Review Comments - Response Letter 4100 Pinetree Drive, Miami Beach, Florida

1: Building/ Accessibility Section B1300102
11/19/2012
Assigned to : MRA
Comment

NEW DEMISING PARTITION AT SUITE 400

301 ARTHUR GODFREY ROAD, MIAIMI BEACH, FLORIDA

Design No. U465 BXUV.U465 Fire Resistance Ratings - ANSI/UL 263

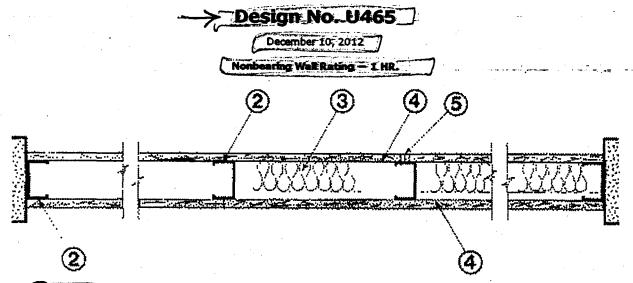
Assigned to : MKA			
	Comment	Responsibility	
6	Provide details for walls to be used, include UL (or other agency) number for fire rated walls, specifying materials to be used. Tenant Separation. Detail shown not same as UL assembly. (111912) SHOW A FULL DETAIL AS PER ASSEMBLY.	Arch	
O	Hot same as of assembly. (111912) Show A Fold Detail AS PER ASSEMBLY.	Alui

Response	Please see revised Sheet A-100 and attached full UL detail for Design No. U465.	TFG	
	Provide UL (or other agency) number and details for Fire Resistant Joint System		
	to be used (FBC 713). See also 2004 UL Directory, pages 1145 thru 1562. Detail		
	shown not same as UL assembly. (111912) SHOW A FULL DETAIL AS PER		
7	ASSEMBLY.	Arch	
	Please see revised Sheet A-100 and attached full UL detail for Fire Rated Joint

POWER PLAN

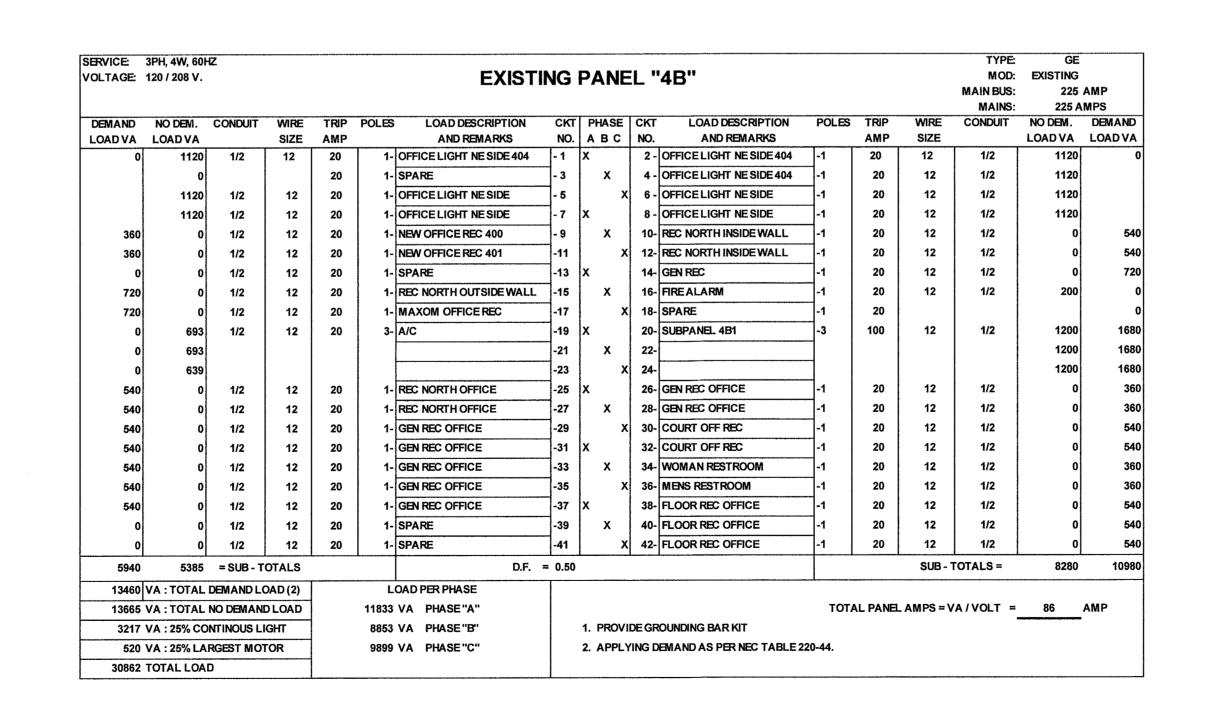
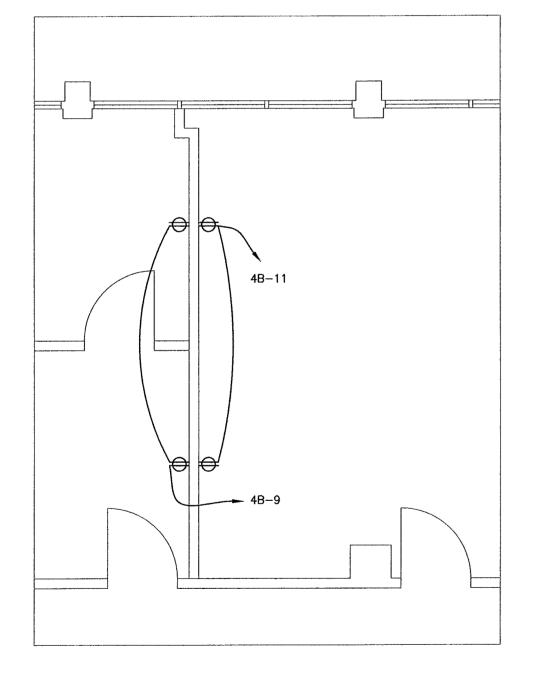
Response	System No. HW-D-0003.	TFG	
2: Electrical Section B1300102		Response	
	11/5/2012	12/14/2012	
	Assigned to : EJM		
	Comment	Responsibility	
1	PROVIDE BRANCH CIRCUIT ID # IN FLOOR PLANS AND PNL SCH TO MATCH IT.	МЕР

Response	Please see New Electrical Sheet E-100 for requested circuit and panel schedule information.	•ffg.•
